When we reviewed the “Moorebank Intermodal Precinct West – Stage 3 (SSD 10341), Traffic Assessment”, we were somewhat surprised with the expected performances of the intersections on Moorebank Avenue.

For now, we focus on the Moorebank Av – M5 intersection as shown in the Traffic Assessment.

Figure 2 Relevant page from M1CL EIS

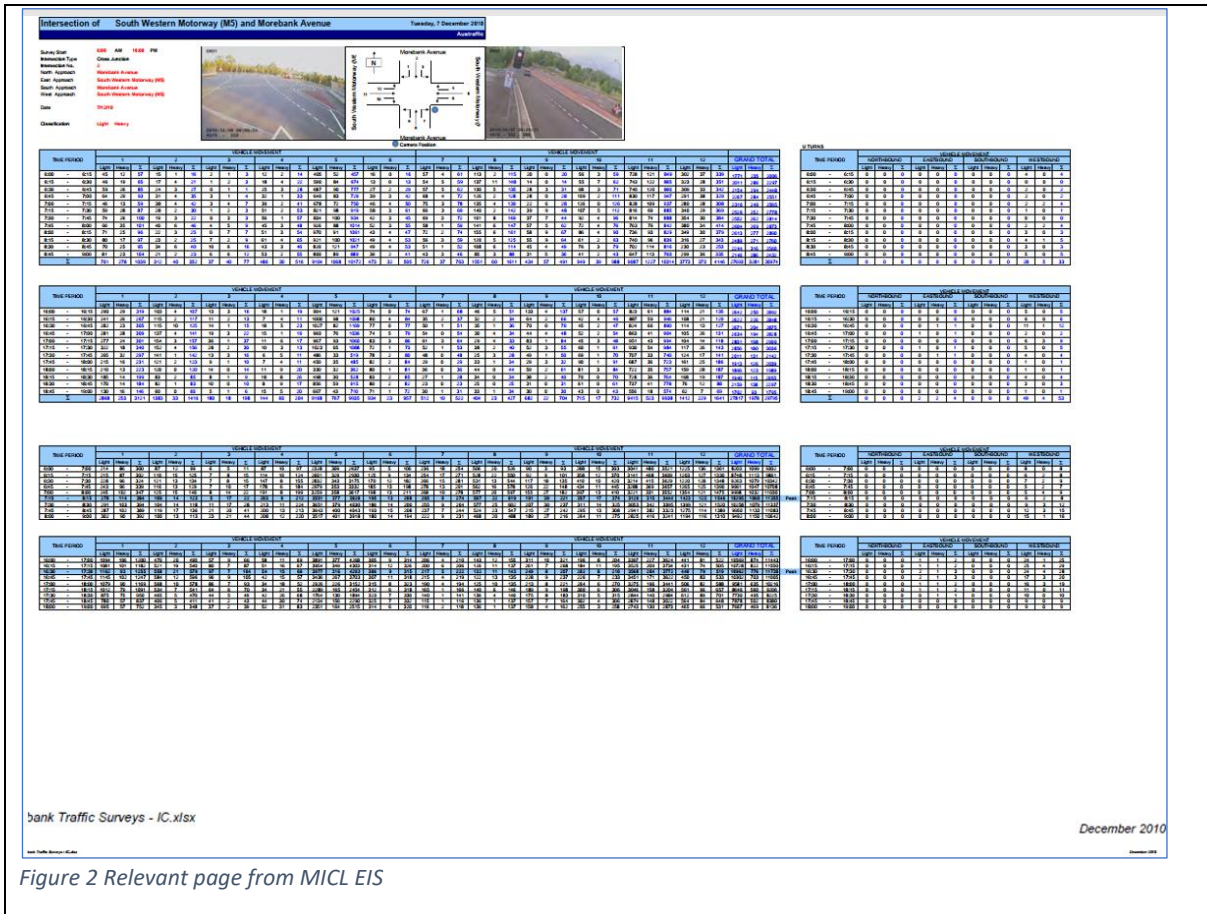
For reference we compared these flows to those that were surveyed on 07/12/2010 for the Moorebank Intermodal Company (MICAL), Environmental Impact Statement (EIS). For convenience, the page is reproduced in Figure 2.

Figure 3 shows the numbers more clearly, and the page out of the EIS is not so legible. The table shows the AM hourly flows. The header shows the coding system for the numbers in the table.

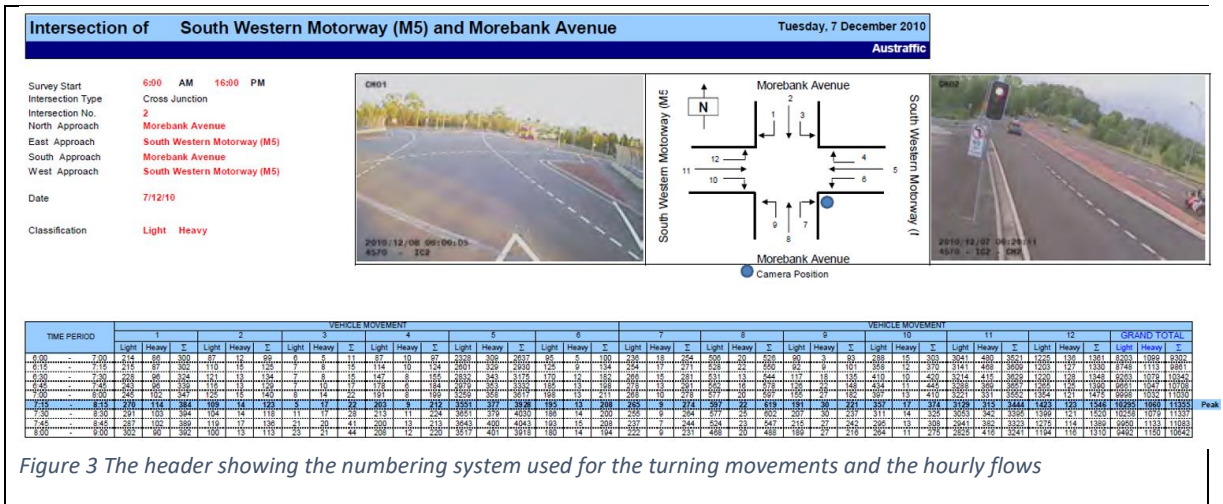
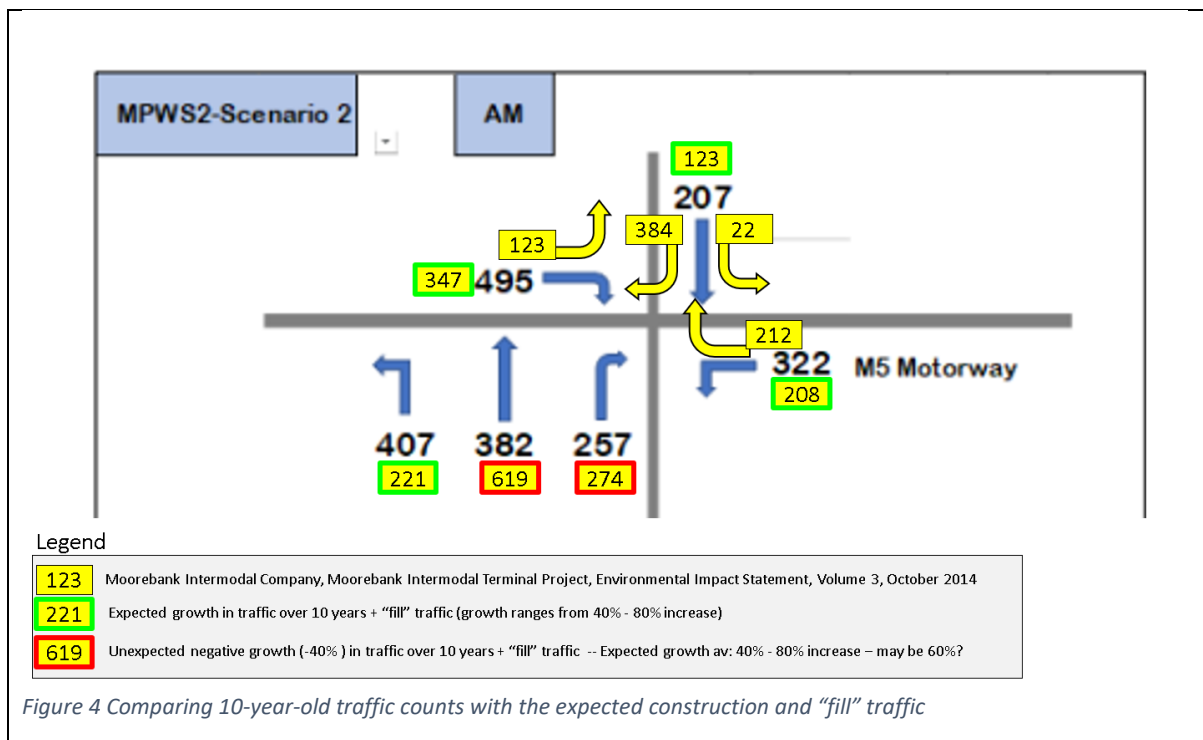
For completeness, all the MICL, EIS flows are shown in yellow boxes, together with the movement arrows. All the yellow boxes show the 10-year-old MICL, EIS numbers.

The yellow boxes with green borders have numbers which are lower numbers than the Traffic Assessment numbers. This is fully expected. There is the 10-year growth in traffic, and the additional construction and "fill" traffic. The growth in traffic varies from 40% to 80%.

The yellow boxes with the red borders have numbers that are higher than the Traffic Assessment numbers.

In the northbound direction, the Traffic Assessment number is 237 vehicles per hour less than the 10-year-old EIS number, and 17 vehicles per hour less for the right-hand-turning movement.

The expected northbound traffic flow represents a **negative growth of 40% over the 10-year old surveyed flows**. Intuitively, the expected number of northbound traffic would consist of two parts: (1) add 40% to bring it to the surveyed flows 10 years ago, then (2) add the expected natural growth as well as the additional construction and "fill" traffic (for the other movements, that ranges from 40% to 80%). Based on this logic, in round figures, the expected northbound traffic should be about double the quoted figure.

From the Traffic Assessment report, it is not immediately obvious why the expected flow is only 40% of the 10-year old surveyed flows.

Figure 5 shows the calculation to estimate (1) all traffic travelling southbound, and (2) traffic arriving at the next intersection. In this example, 217 vehicles disappear between two very closely spaced intersections.

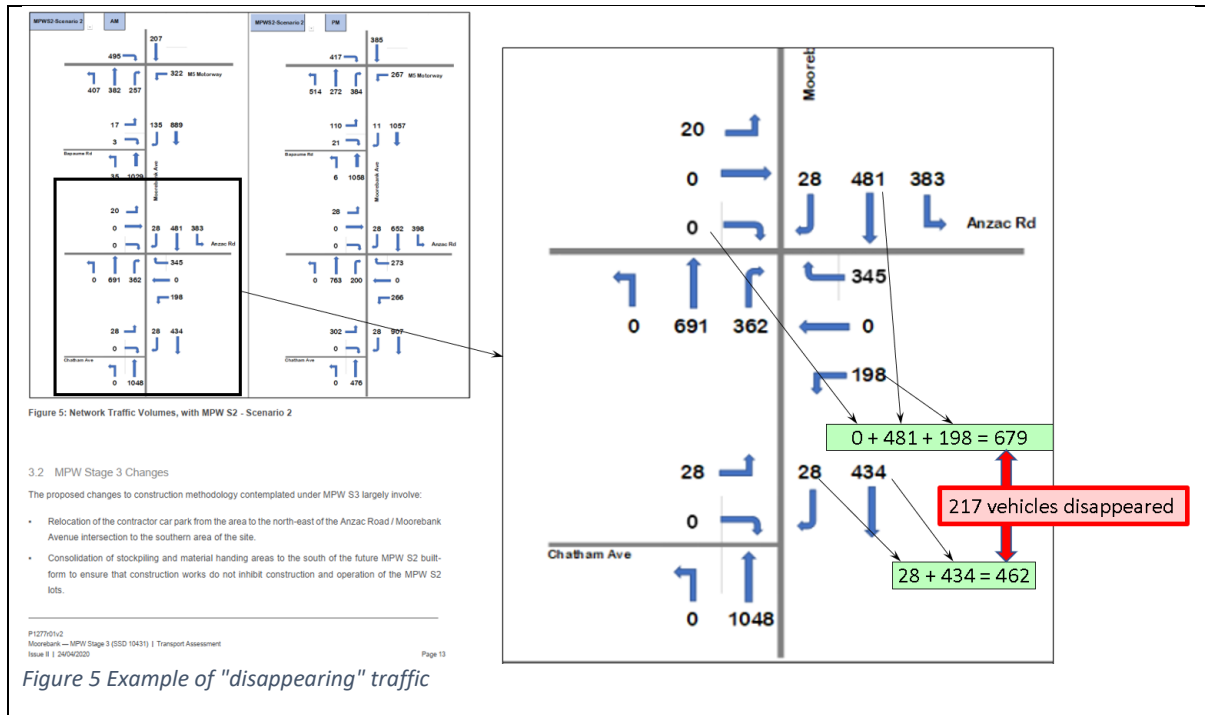
No explanation is given on the AM northbound traffic being only 40% of the 10-year old surveyed flow, nor the 217 disappearing vehicles. A simple exercise will show several other instances which do not make sense.
